Access Compliance Report

Public Rights-of-Way

Intersection ID: 46805	Main Street: ARBOR_CREST_CT	Cross Street: RED_BIRCH_DR	Location: E
ADA ID: 06F59F4B66FF	Ramp Type: Perp	Initial Pass/Fail: Fail	Overall Compliance: No
Severity Score: 13.75			
Codes/Mitigation Info/Possible Solution		Field Measurements/Component Compliance

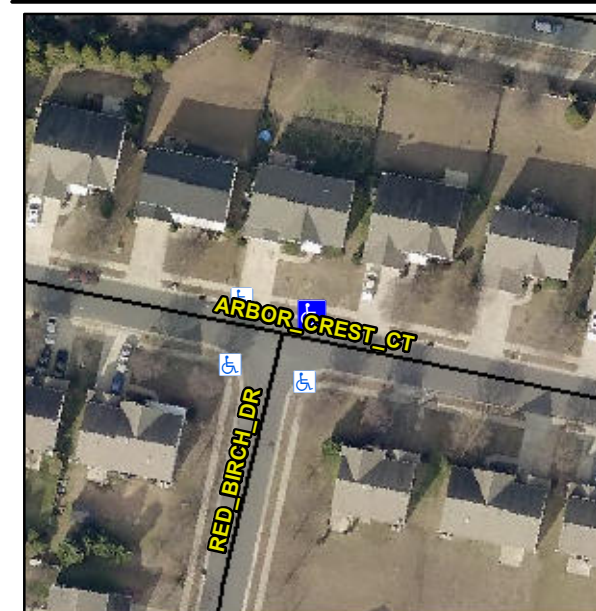
Not Found, R304.2.2

Compliance	Description	Data	Compliance	Description	Data
N/A	Ramp Length (in)	48.0	No	Ramp Slope (%)	8.4
Yes	Ramp Width (in)	52.0	Yes	Ramp XSlope (%)	2.6
N/A	Flare Type LT	N/A	N/A	Flare Type RT	N/A
N/A	Flare Slope LT (%)	N/A	N/A	Flare Slope RT (%)	N/A
N/A	Flare Traversable LT?	N/A	N/A	Flare Traversable RT?	N/A
N/A	Landing Length (in)	N/A	N/A	DWS Provided?	N/A
N/A	Landing Width (in)	N/A	N/A	DWS Contrast?	N/A
N/A	Landing Slope (%)	N/A	N/A	DWS Length (in)	N/A
N/A	Landing X Slope (%)	N/A	N/A	DWS Full Width?	N/A
N/A	Landing Curb? (Y/N)	N/A	N/A	DWS Offset (in)	N/A
N/A	Shared Landing?	N/A			
N/A	Gutter Ponding?	N/A	N/A	Gutter Slope (%)	N/A
N/A	Gutter Lip Ht (in)	N/A	N/A	Gutter X Slope (%)	N/A
N/A	Painted X Walk1?	No	N/A	Painted X Walk2?	N/A
	X Walk 1 Direction	To SW		X Walk 2 Direction	N/A
N/A	X Walk 1 Width (in)	N/A	N/A	X Walk 2 Width (in)	N/A
	X Walk 1 Slope (%)	3.2		X Walk 2 Slope (%)	N/A
	X Walk 1 X Slope (%)	3.1		X Walk 2 X Slope (%)	N/A

Remove & Replace Entire Ramp.
